December 29, 2025

CONTRACT NO. 1797

OHIO RIVER TUNNEL

ADDENDUM No. 11

Utility Inspection Coverage Exhibits

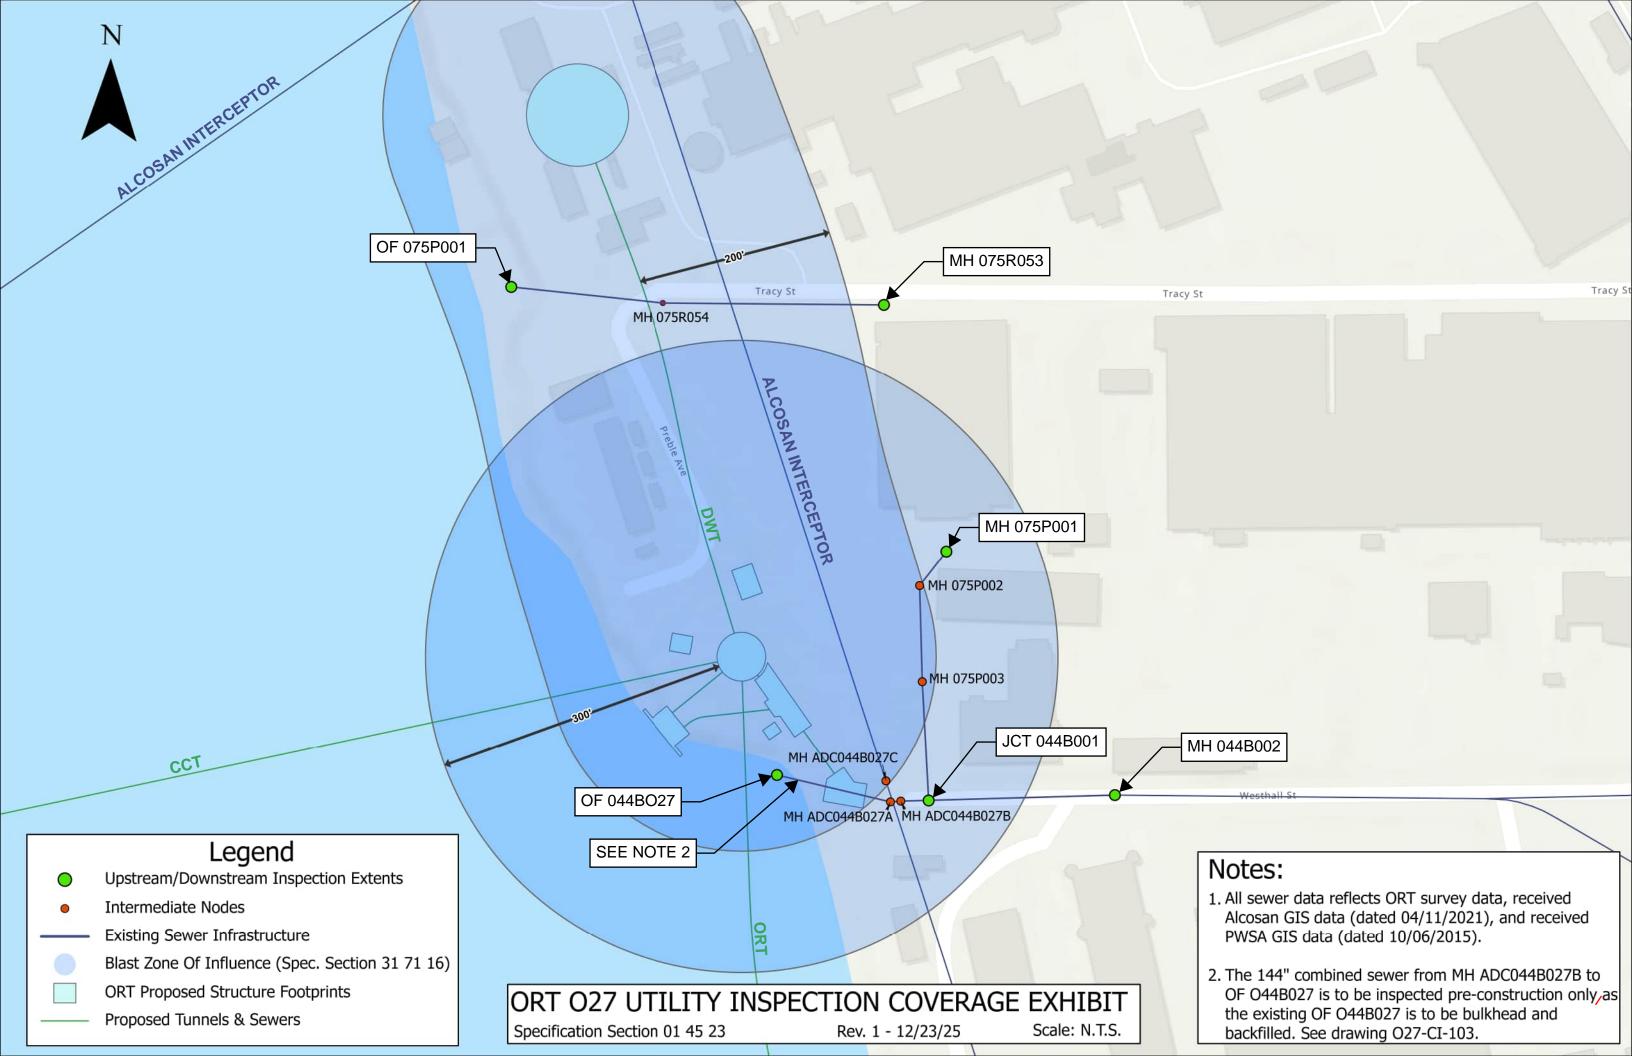
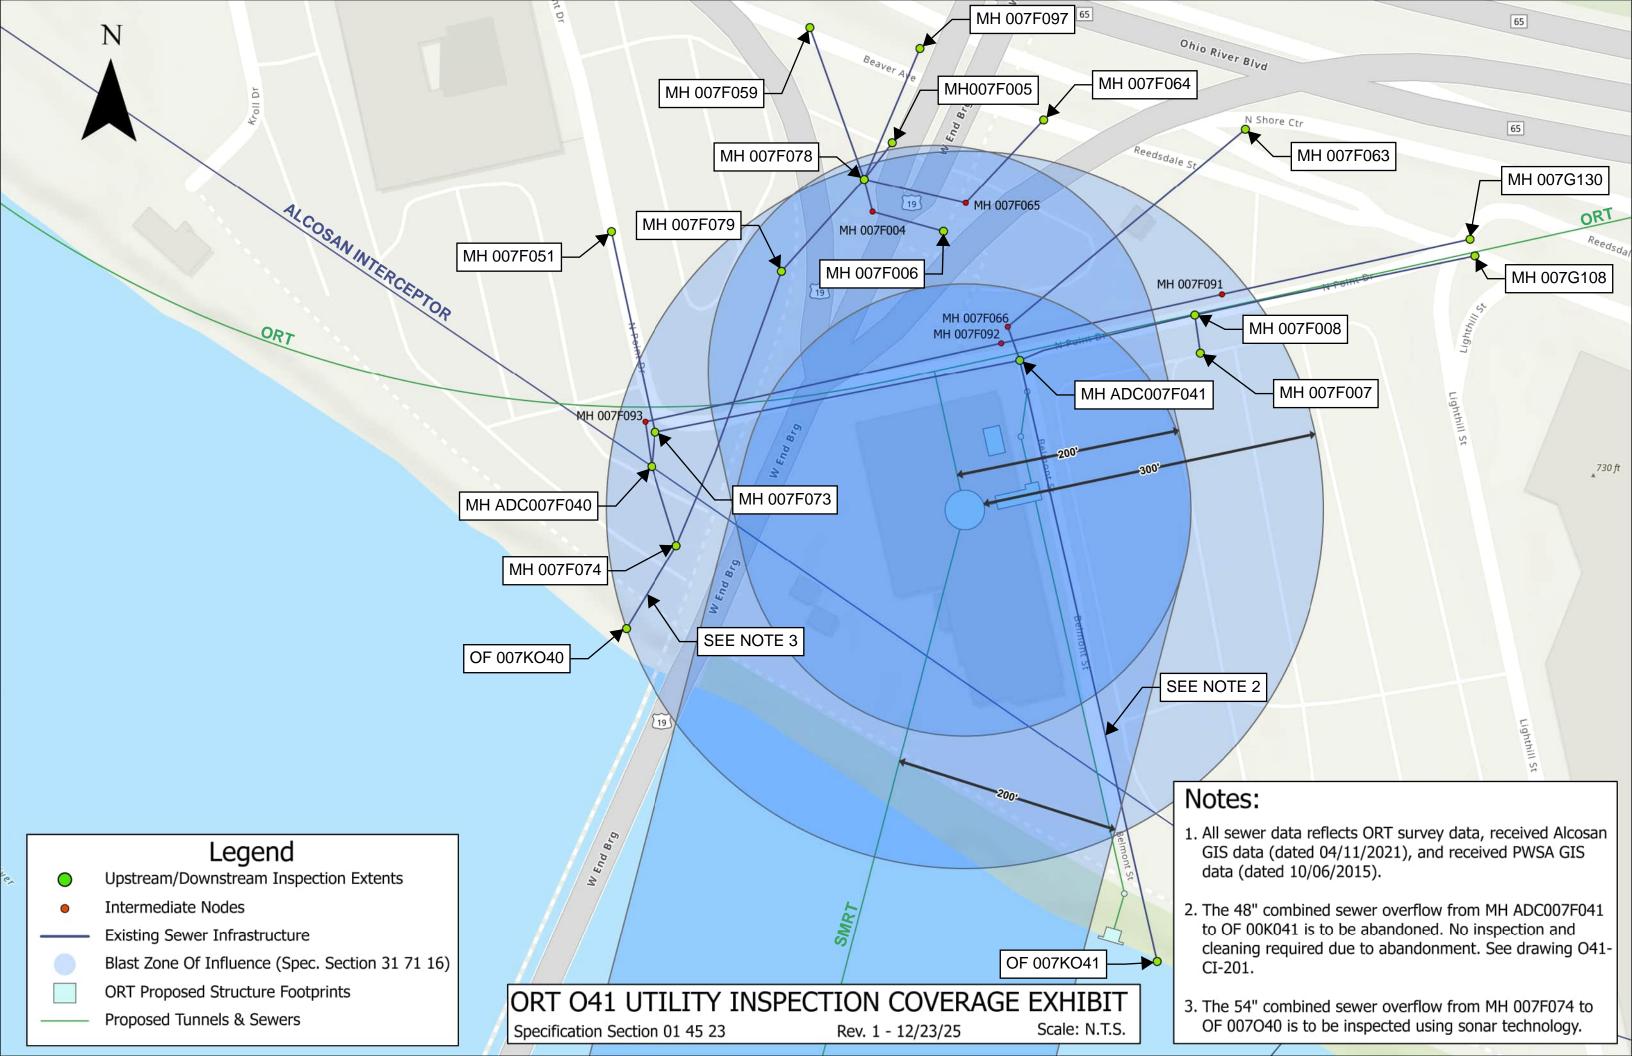
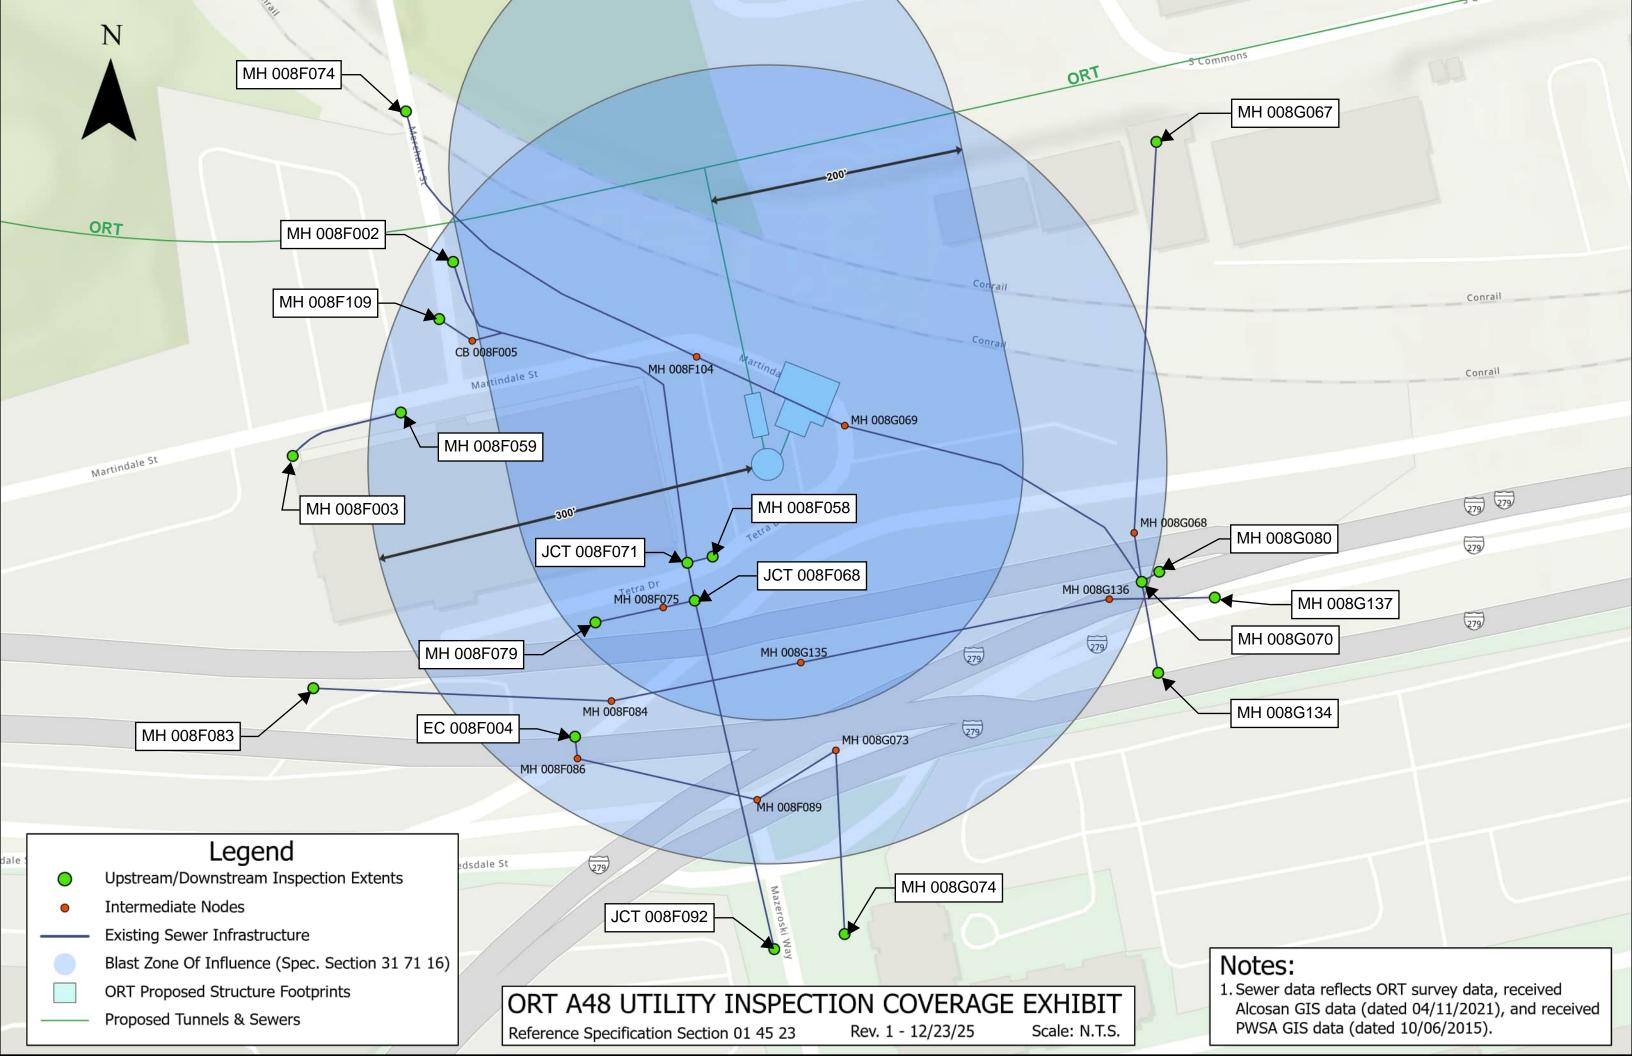
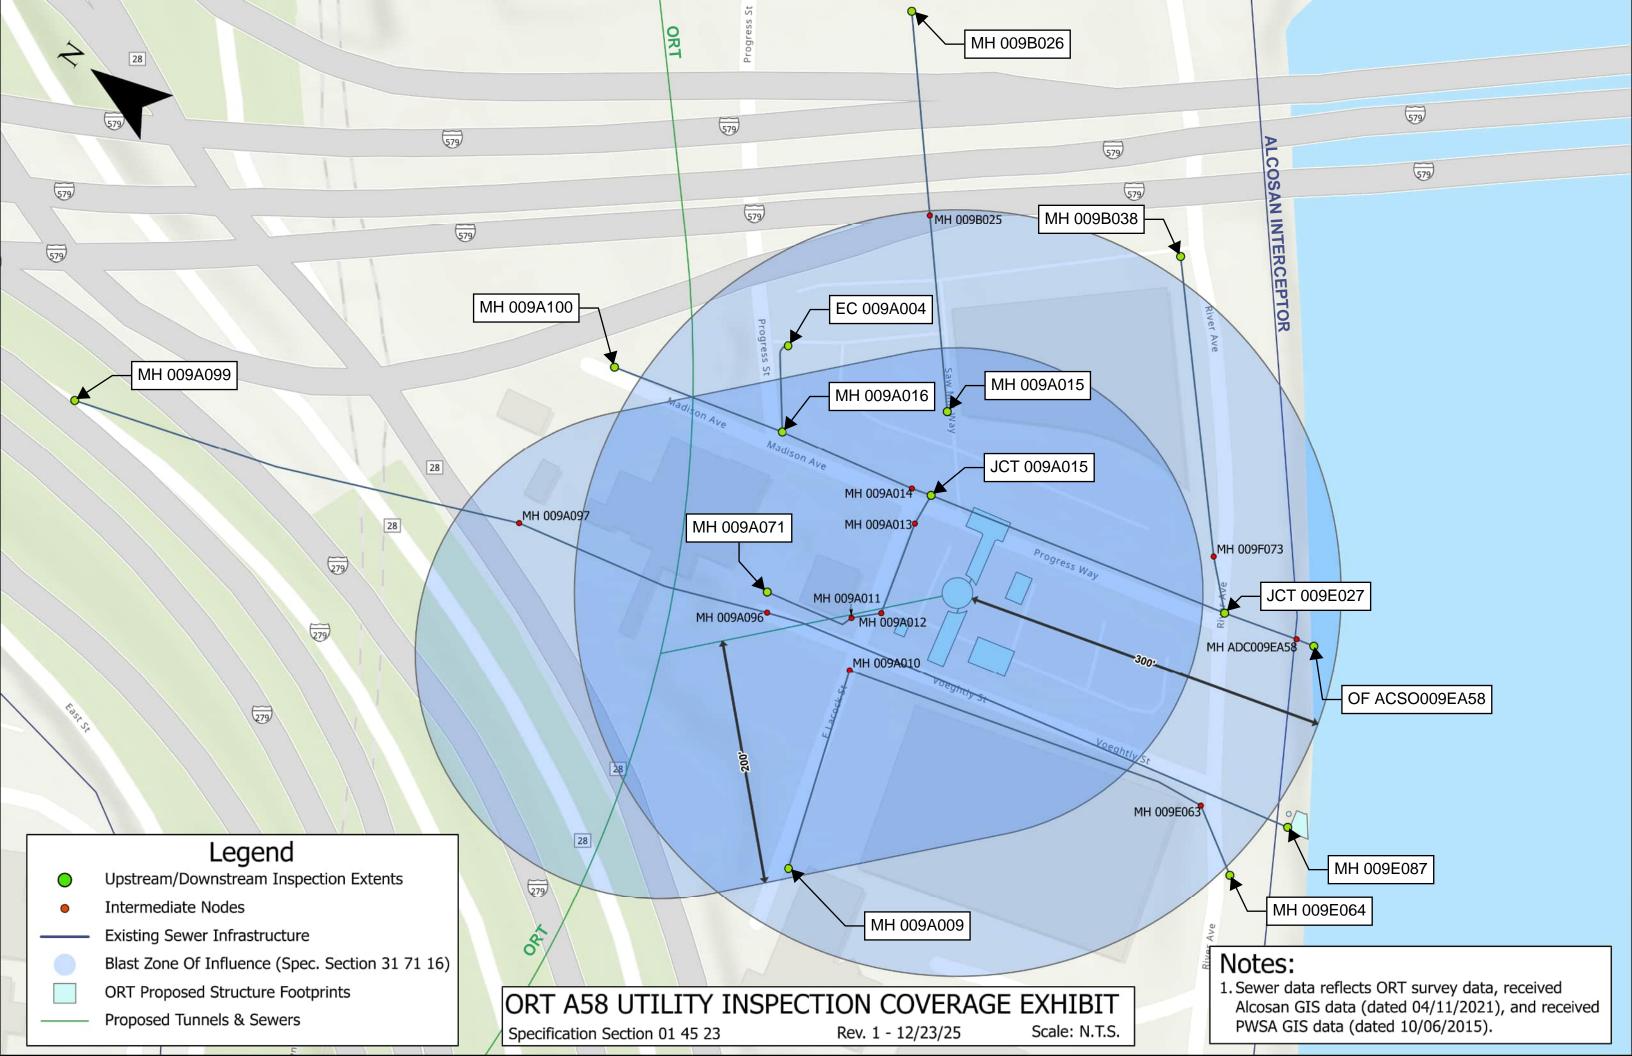
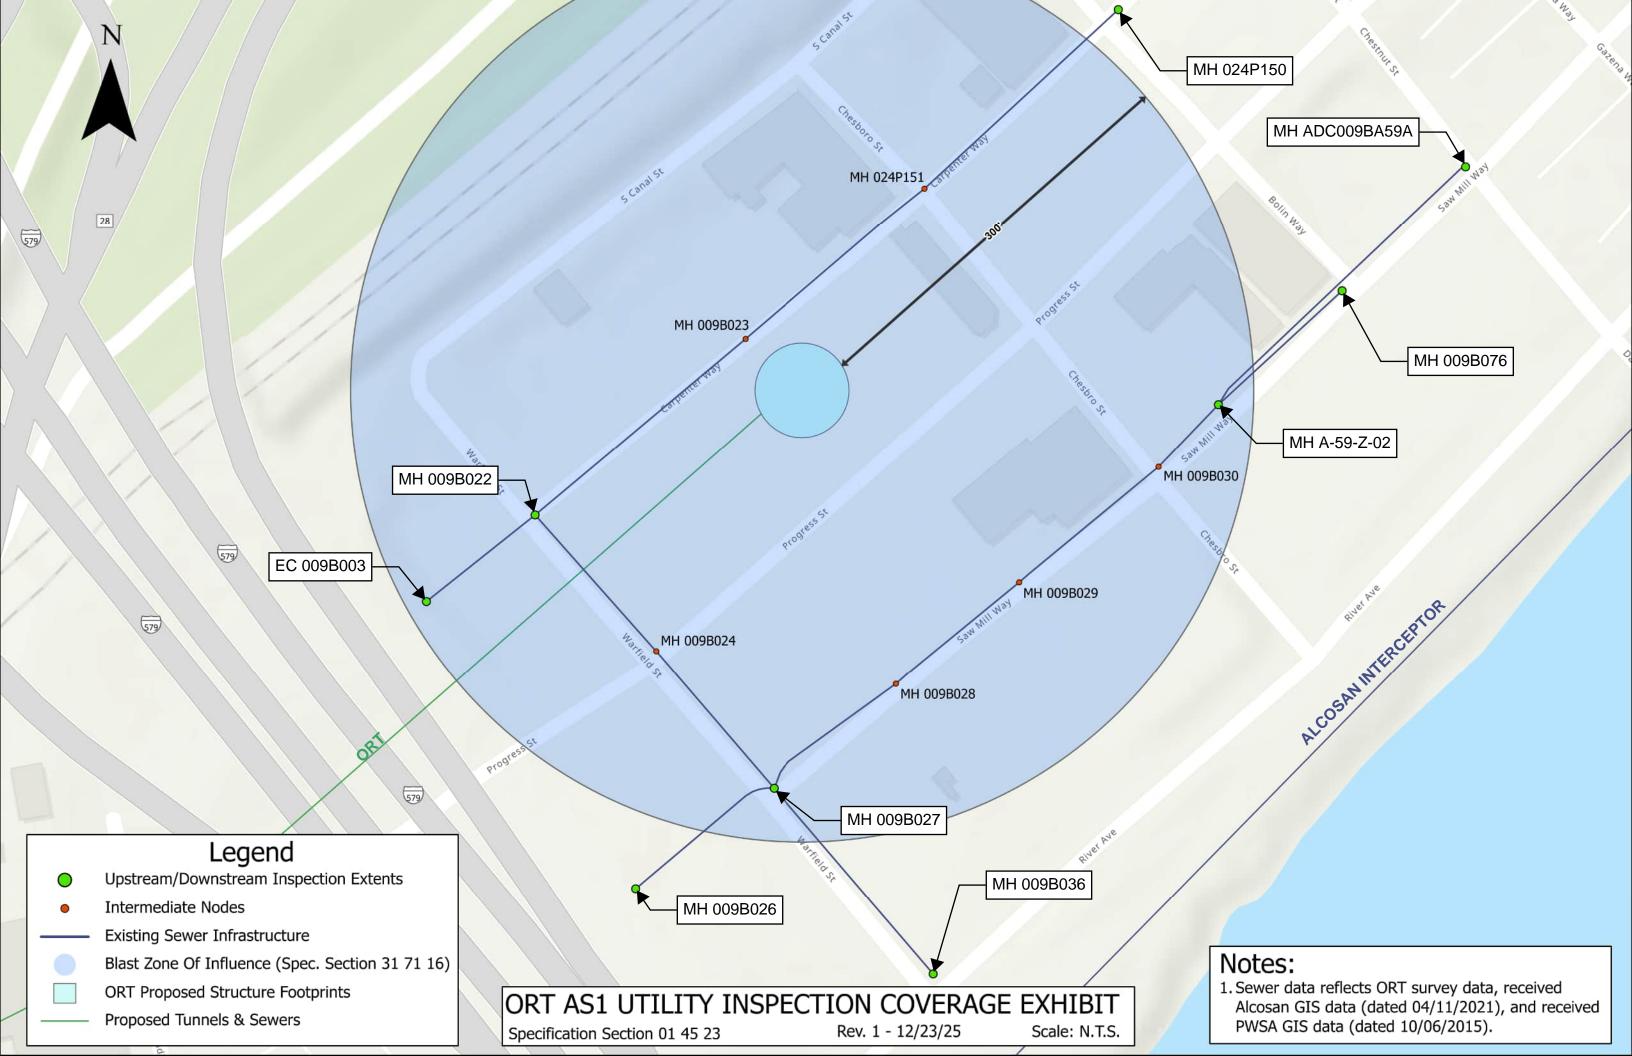
Q4 Attachment 2 from Specification 01 45 23, in the section for site O14, lists the cleaning and inspection of a 15" VCP and 30" RCP from MH 007P029 to MH 1D. The Utility Inspection Limit Map provided with Addendum 4 appears to show the 15" passing through MH 007P023 and into MH-N0 and, apparently, the 30" running from MH-N0 to MH1D. Drawing O14-CI-608 appears to show a different routing. The 15" appears to dead-end into the 42" RCP and the 30" appears to run from MH-N0 to a dead-end into the 48" RCP. Several questions arise:

- A) Refer to O14-CI-600 for the presumed routing of the sewer line based on field survey and CCTV inspection documentation. This information generally aligns with the Utility Inspection Coverage Exhibits included in Addendum 4, Attachment B.
 - B) Bidders to assume that the existing 15" and the existing 30" sewer lines may be influenced during dry weather.
 - C) Suggestion accepted. Replace Specification Section 01 45 23, Attachment 2 in its entirety with Specification Section 01 45 23, Attachment 2 REVISED 12/23/25. See Item 4 and Attachment A of this Addendum for CHANGES TO CONTRACT DOCUMENTS. Exhibits added to APPENDIX E –

SUPPLEMENTAL INFORMATION in Addendum 4 have been REVISED. See Attachment B of this Addendum.
